REMARKS/ARGUMENTS

Amendments to the Figures

Int. Appl. No.: PCT/US02/15387
U.S. Appl. No.: 10/712,060
Amdt. dated: July 19, 2005

FIG. 1a

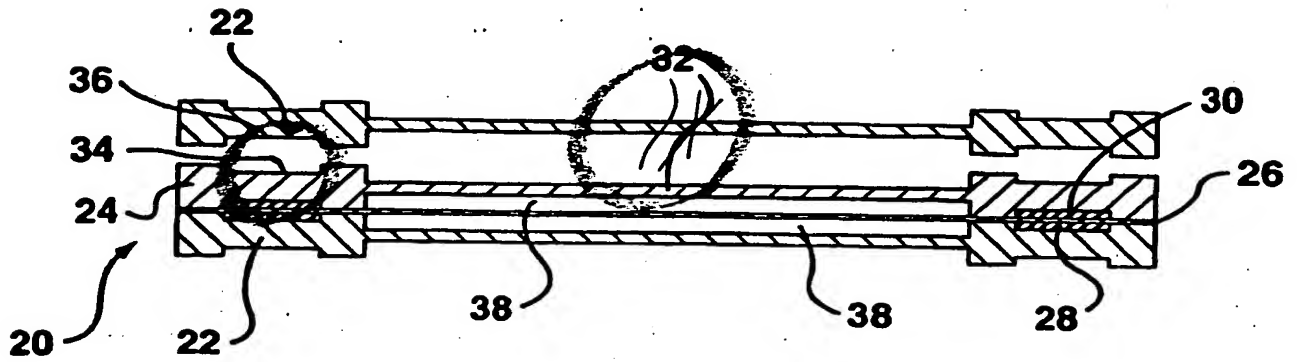
With respect to the drawings, amendments are being made to Figures 1a-e, 2, 7-12, and 17. In Figures 1 and 2, the amendments to the lead lines are intended merely to ensure that these drawings are wholly consistent with the specification and to aid in understanding the drawings. In Figure 7, the connection apertures have been labeled with reference numeral 160. In Figure 8, for consistency with Figure 7, the references

FIG. 8

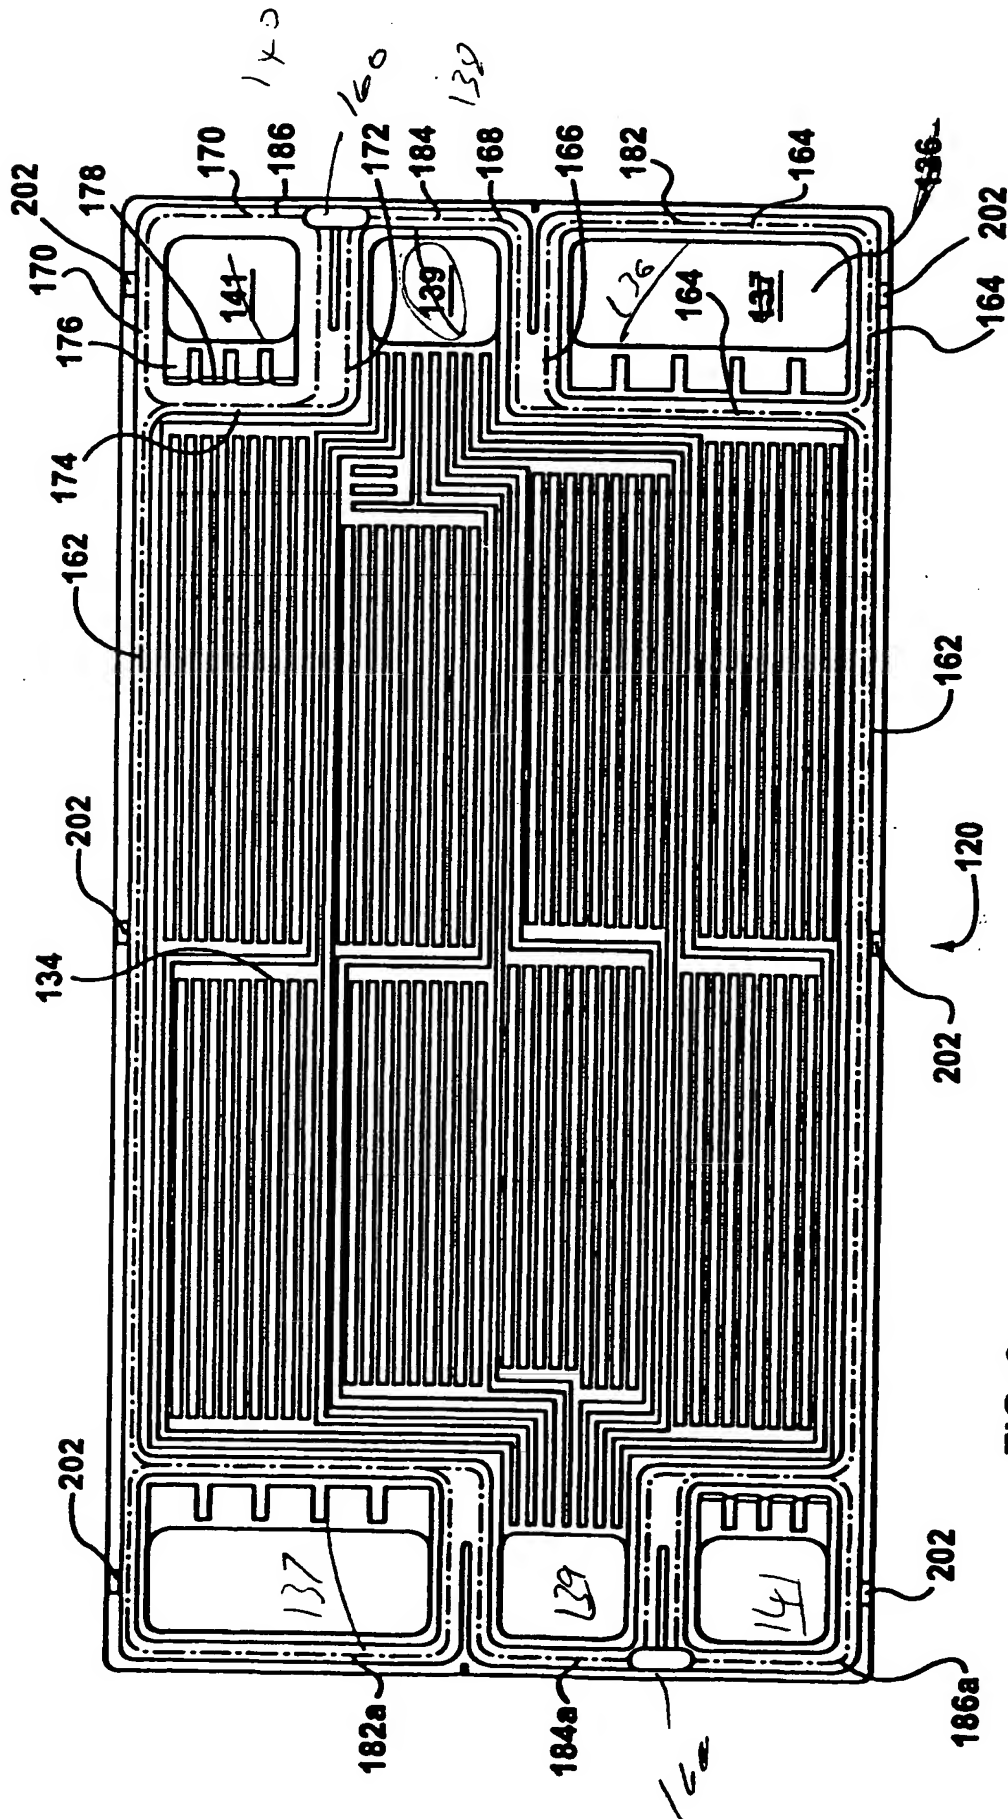
137, 139 and 141 now denote ports on the left hand side, while references 136, 138 and 140 denote ports on the right hand side. In Figure 9, the connection apertures have been labeled with reference numeral 160. In Figure 10, the reference numerals 182', 184' and 186' are, in effect, being switched with the reference numerals 182a', 184a' and 186a'. In Figure 11, at the right hand side reference numeral 160e has been amended to read 160ae and the reference 160e added on the left hand side; at the top 132 has been corrected to 192. In Figure 12, the sealing aperture has been labeled with reference numeral 160e. In Figure 17, the lead line for reference numeral 146 has been extended to point to the sealing groove to ensure that the drawing is wholly consistent with the specification. These amendments are simply intended to ensure consistent use with the reference numerals used in the Figures and the description and for clarity in the drawings.
